UNITED STATES PATENT AND TRADEMARK OFFICE

APPLICATION NO.	FILING DATE	FIRST NAMED INVENTOR	ATTORNEY DOCKET NO.	CONFIRMATION NO.
09/677,870	10/03/2000	Woo Hyuk Choi	2658-0240P	6124
2292	7590	07/13/2004	EXAMINER	
BIRCH STEWART KOLASCH & BIRCH PO BOX 747 FALLS CHURCH, VA 22040-0747			RUDE, TIMOTHY L	
			ART UNIT	PAPER NUMBER
			2871

Office Action Summary

DETAILED ACTION

FIG. 6

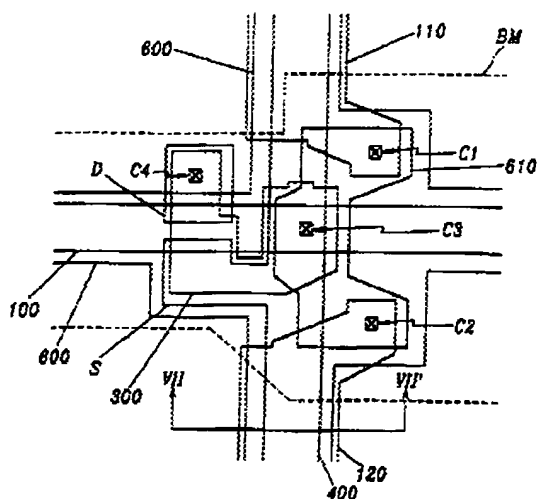
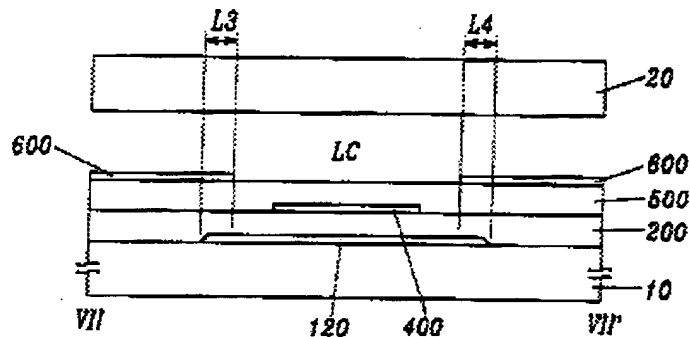
As to claims 1, 8, and 21, Kim discloses in the third embodiment, Figures 6 and 7, (col. 6, line 35 through col. 7, line 5), a thin film transistor substrate in a liquid crystal display provided with a data line, 400, for applying a data signal, a gate line, 100, for applying a gate signal, and a transparent pixel electrode, 600, for driving a liquid crystal cell, said substrate comprising: repair lines, 110 and 120, (Applicant's gate dummy pattern) formed of the same material layer as the gate line (col. 6, lines 38-42 and col. 2, lines 10-17) and formed vertically to the gate line, 100, and to overlap the pixel electrode, 600, and data line 400, to compensate for misalignment occurring along the data line,

Wherein the gate dummy pattern is formed to overlap with an edge portion of the pixel electrode (per Figures 6 and 7), and is separated by gate insulating layer, 200.

Kim does not explicitly disclose a display wherein the gate dummy pattern is integrated with the data line [one possible interpretation of Applicant's "formed vertically to the gate line"].

FIG. 19A

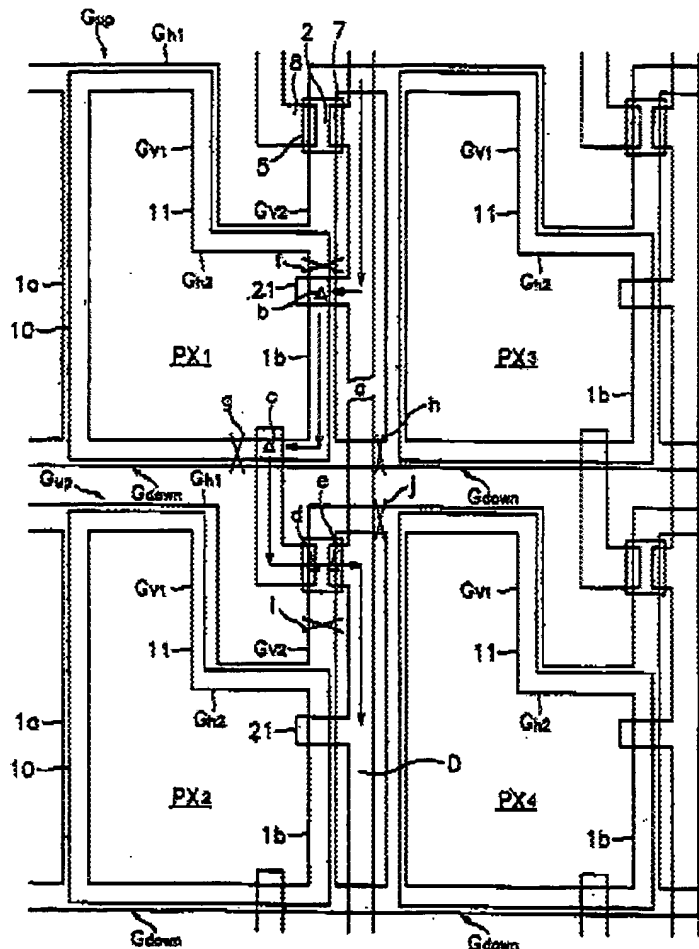
Song teaches the use of a redundant pattern that is integrated with the gate line in Figure 19A (G_{up} and G_{down} or 1a and 1b) as a redundancy electrode for electrically connecting the gate line to the broken data line (col. 17, lines 4-67, especially col. 17, lines 47-54) to effect repairs.

Song is evidence that ordinary workers in the art of liquid crystals would find the reason, suggestion, or motivation to form the gate dummy pattern in such a manner as to serve as a redundancy electrode for electrically connecting the gate line to the broken data line to effect repairs.

FIG. 13

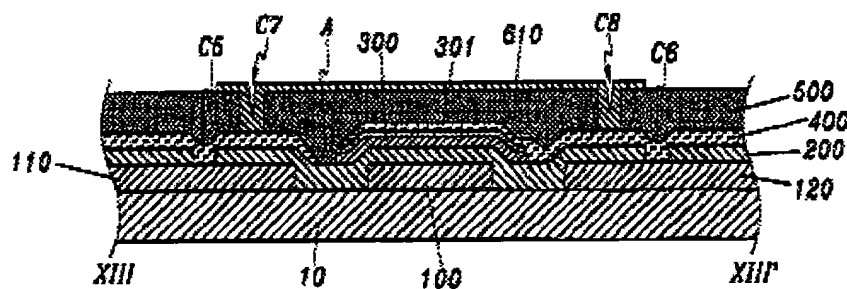
Kim teaches in Figure 13 wherein when the data line is broken, the use of forming holes and connections to the repair lines, 110 and 120, (Applicant's gate dummy pattern) and to a connecting pattern, 610, to repair a broken data line, 400, (col. 8, lines 1-15).

FIG. 26

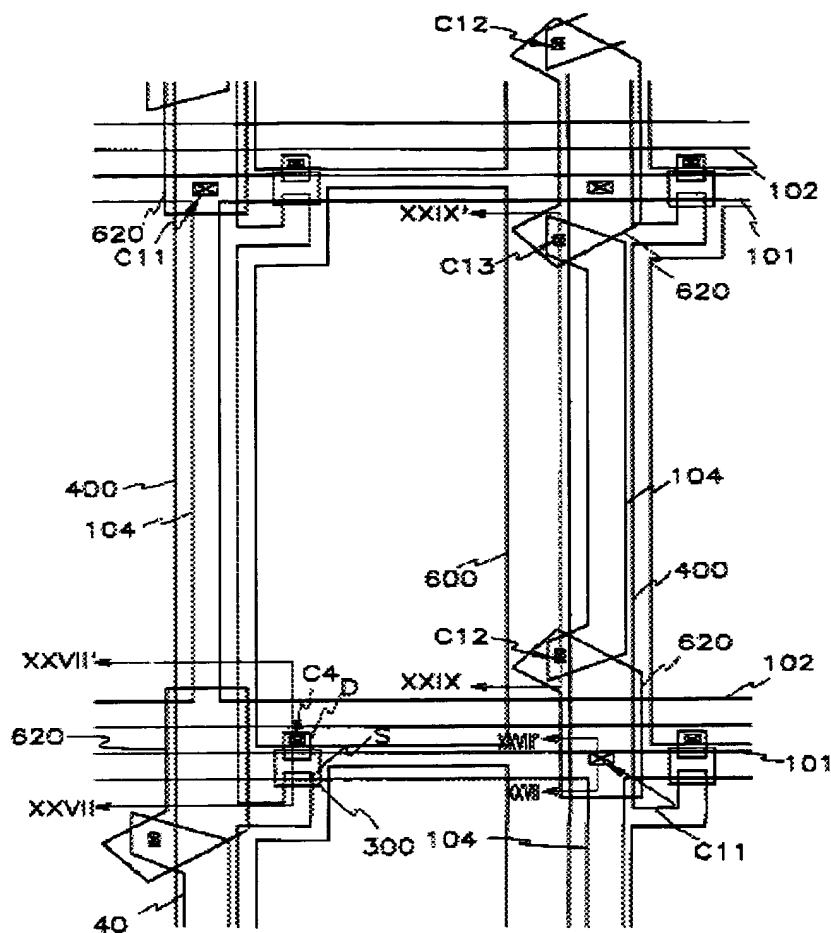
Kim teaches in Figure 26 the use of repair lines, 104, (Applicant's gate dummy pattern used as a redundancy electrode) to connect the gate line to the data line (col. 13, lines 4-17).

Kim is evidence that ordinary workers in the art of liquid crystals would find the reason, suggestion, or motivation to form holes and connect gate dummy patterns to gate lines to repair a broken data line.

FIG. 19A

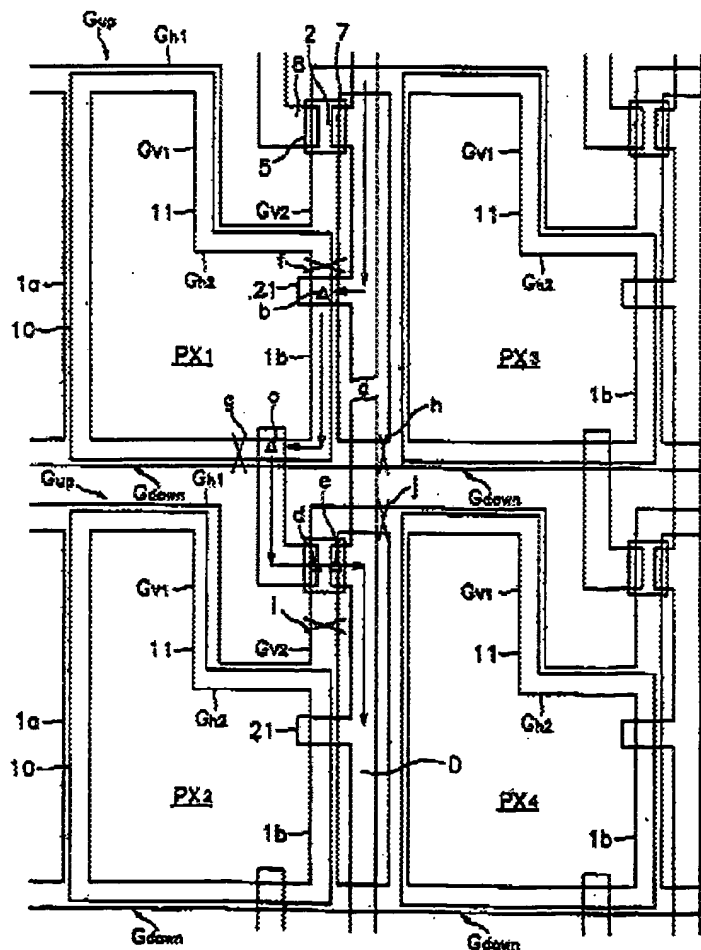
Song teaches, wherein when the data line is broken, the use of a redundant pattern in Figure 19A (G_{up} and G_{down} or 1a and 1b) as a redundancy electrode for electrically connecting the broken data line (col. 17, lines 4-67, especially col. 17, lines 47-54) to effect repairs.

Song is evidence that ordinary workers in the art of liquid crystals would find the reason, suggestion, or motivation to form the gate dummy pattern in such a manner as to serve as a redundancy electrode for electrically connecting the gate line to the broken data line to effect repairs.

FIG. 18

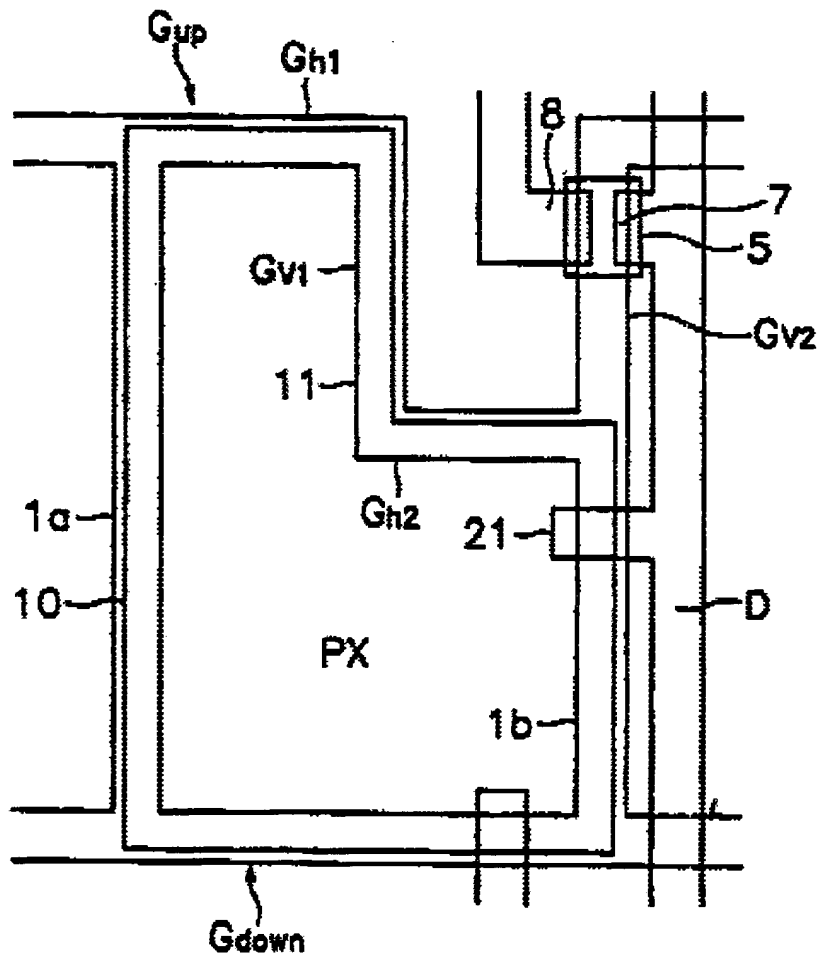
As to claims 6, 15, 22, and 24, and Song teaches in Figure 18 a thin film transistor substrate further comprising: a storage capacitor (col. 15, lines 56-64) defined by a horizontal overlapping part, G_{h2} , between the gate line and the pixel electrode, PX. Song also teaches in Figure 18 an analogous overlapping portion, 21, of the data line, D, to permit a repair. Also, any two conductors separated by an insulator result in a capacitor as a matter of physics. Therefore the overlap region between the pixel electrode and the dummy pattern which are separated by an insulator necessarily forms a capacitor.

As to claims 7 and 16, Song teaches in Figures 18 and 19A a protrusion, 21, protruded from the data line in such a manner to overlap with the intended repair site (Applicant's recess and narrowed portion of the gate dummy patterns), the structure of which would thereby shut off a light leaked between the gate dummy pattern and the gate line (col. 15, lines 42-63). Note that in considering the disclosure of a reference, it
